Rezoning Application: PD 26-0070**Zoning Hearing Master Date:** March 23, 2026**BOCC CPA Public Hearing Date:** May 14, 2026**Hillsborough
County Florida**

Development Services Department

APPLICATION NUMBER: PD 26-0070

AGENCY REVIEW COMMENT SHEET

8.0 PROPOSED SITE PLAN

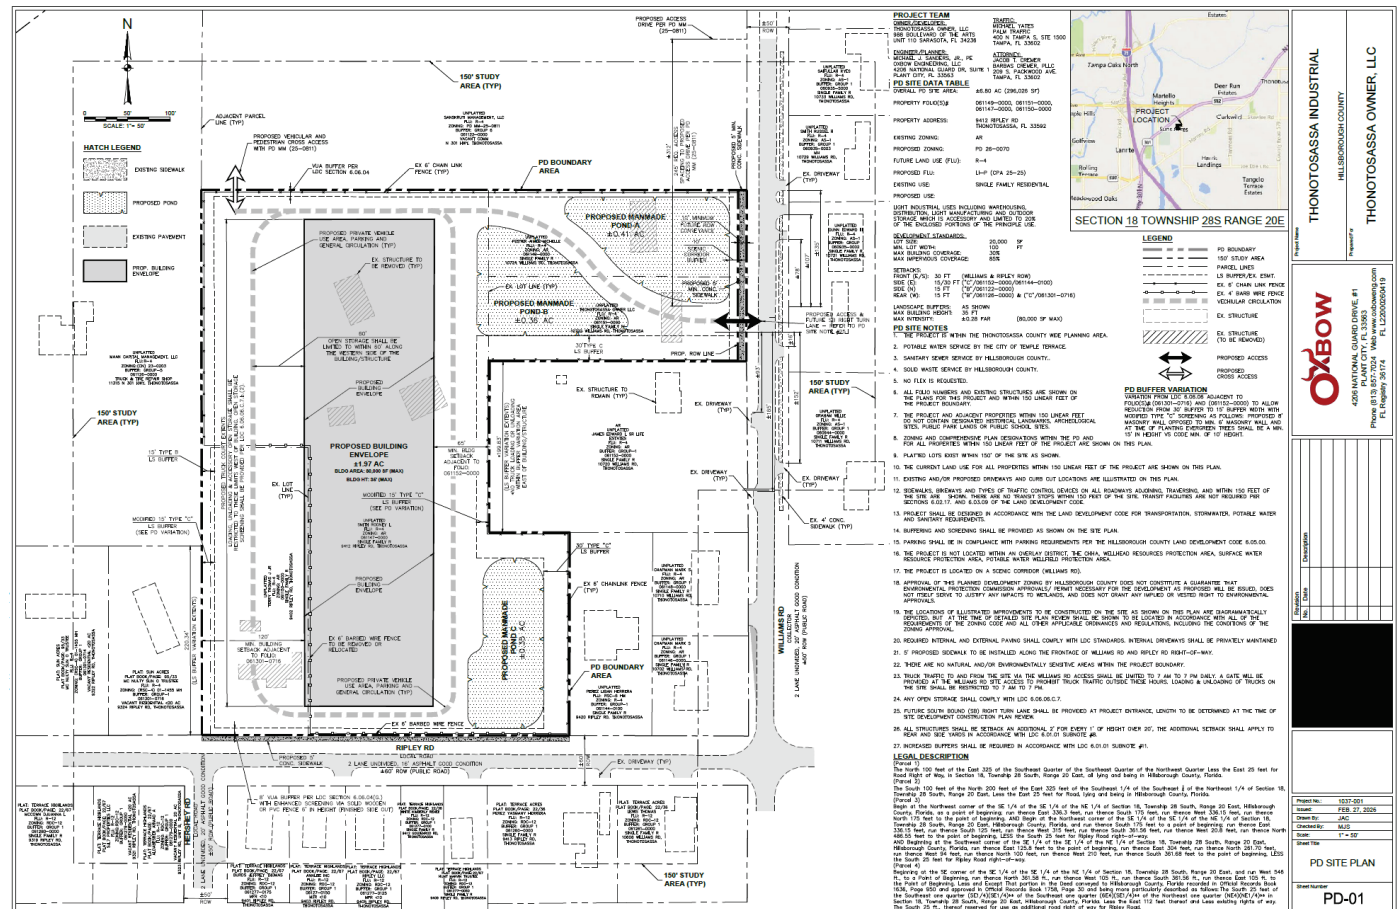
- 1. Add reference to proposed variation regarding the 6' solid wooden/PVC fence along Ripley Road to the site plan.**

FIGURE 2: SITE PLAN with ACCESS SPACING

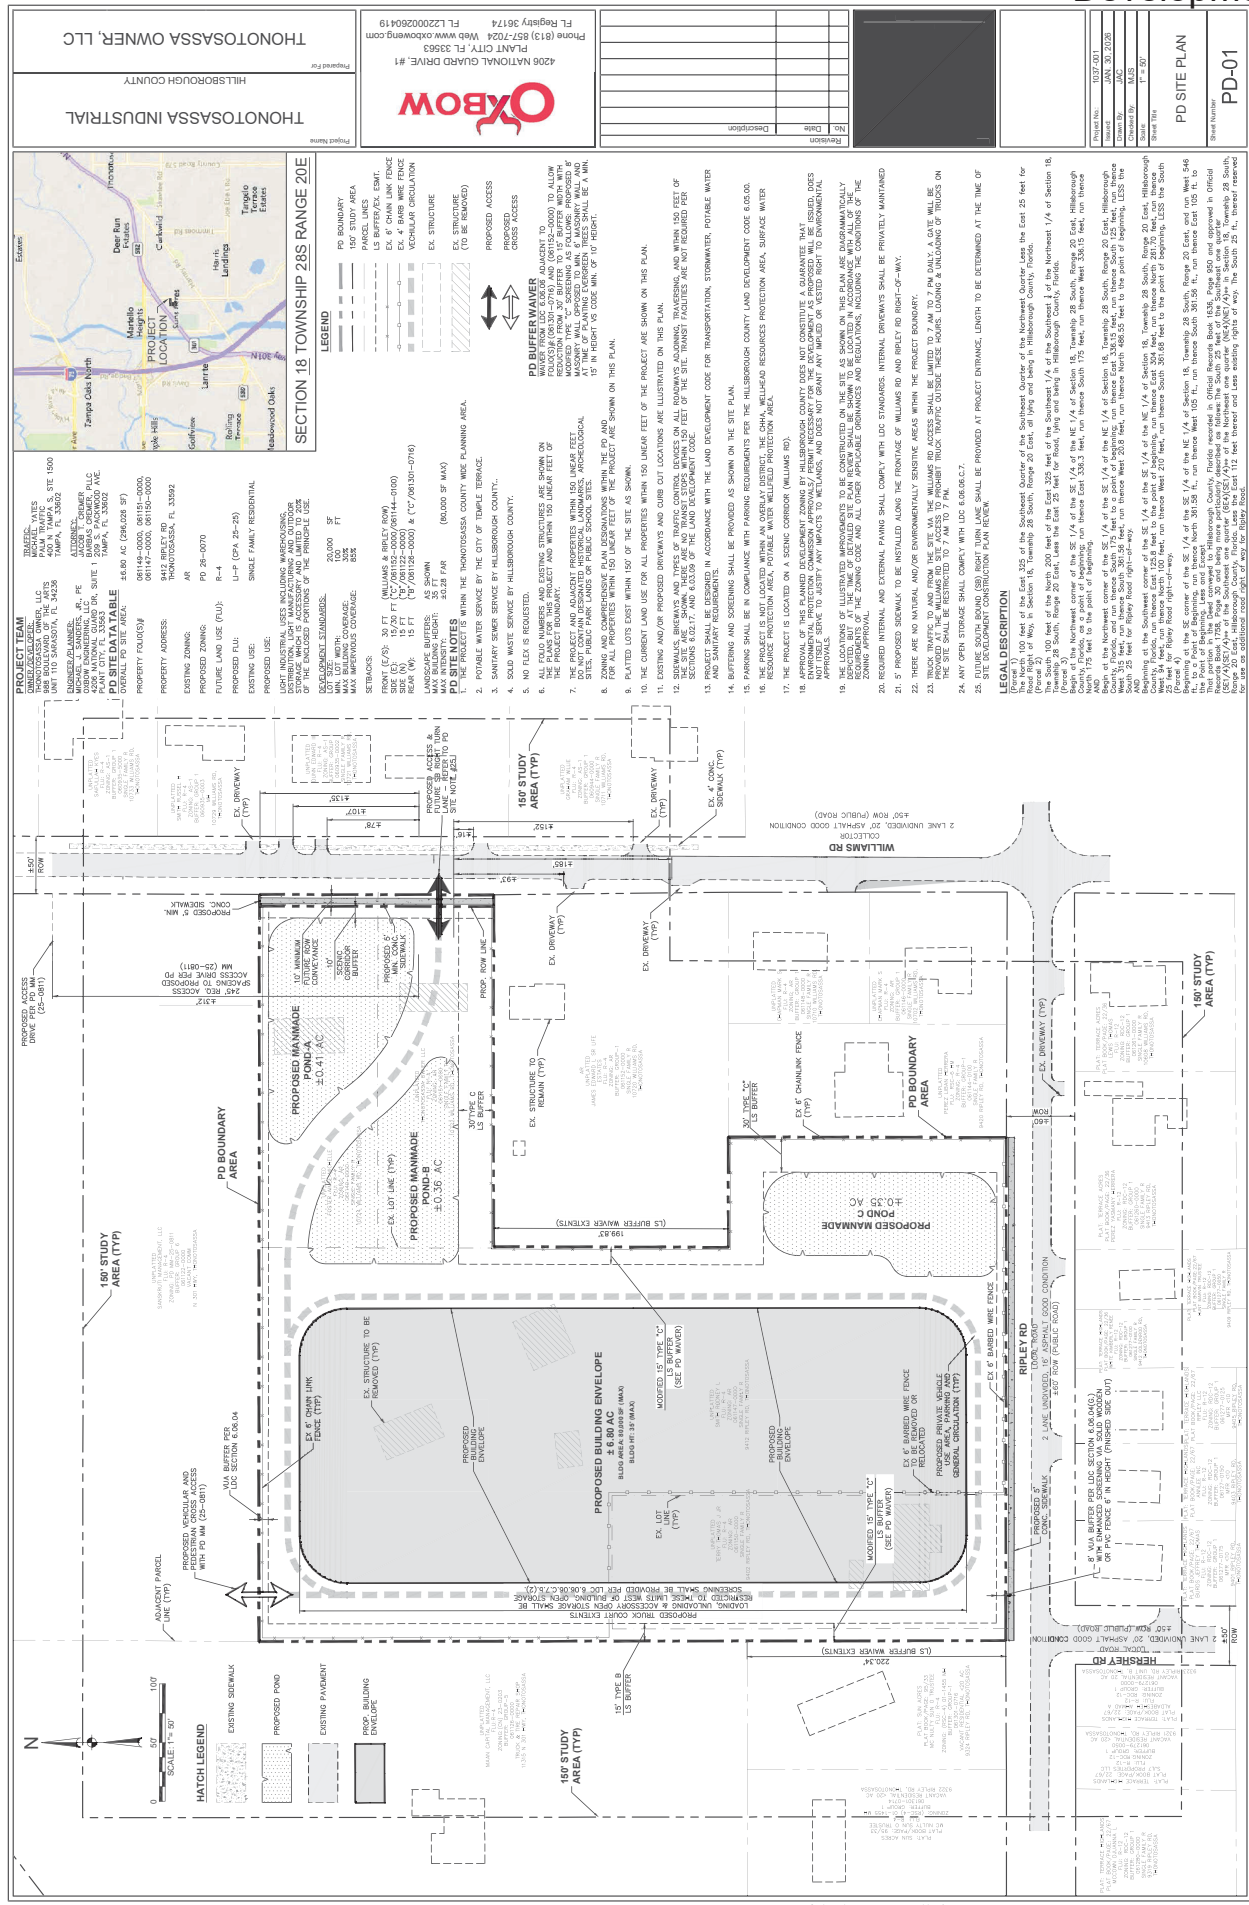
The applicant's EOR submitted a Section 6.04.02.B. Administrative Variance Request (dated February 5, 2026) from the Section 6.04.07 LDC requirement governing access spacing. Per the LDC, Williams Rd is a Class 5 roadway, which requires minimum connection spacing of 245 feet. The applicant is seeking the following variances relative to its project's proposed access connection on Williams Rd:

The request is for an Administrative Variance to Section 6.04.08 of the Hillsborough County LDC for the access spacing to Williams Road. Based on Section 6.04.08, the connection spacing for Williams Road is 245 feet. As shown in Figure 2, the driveway spacing provided ranges from approximately 16 feet to 152 feet, all low volume residential driveways.

Based on factors presented in the Administrative Variance Request, the County Engineer found the request approvable subject to conditions (on March 9, 2026). If PD 26-0070 is approved, the County Engineer will approve the above referenced Administrative Variance request.

I have found the attached Section 6.04.02.B. Administrative Variance (AV) for PD 26-0070 APPROVABLE.
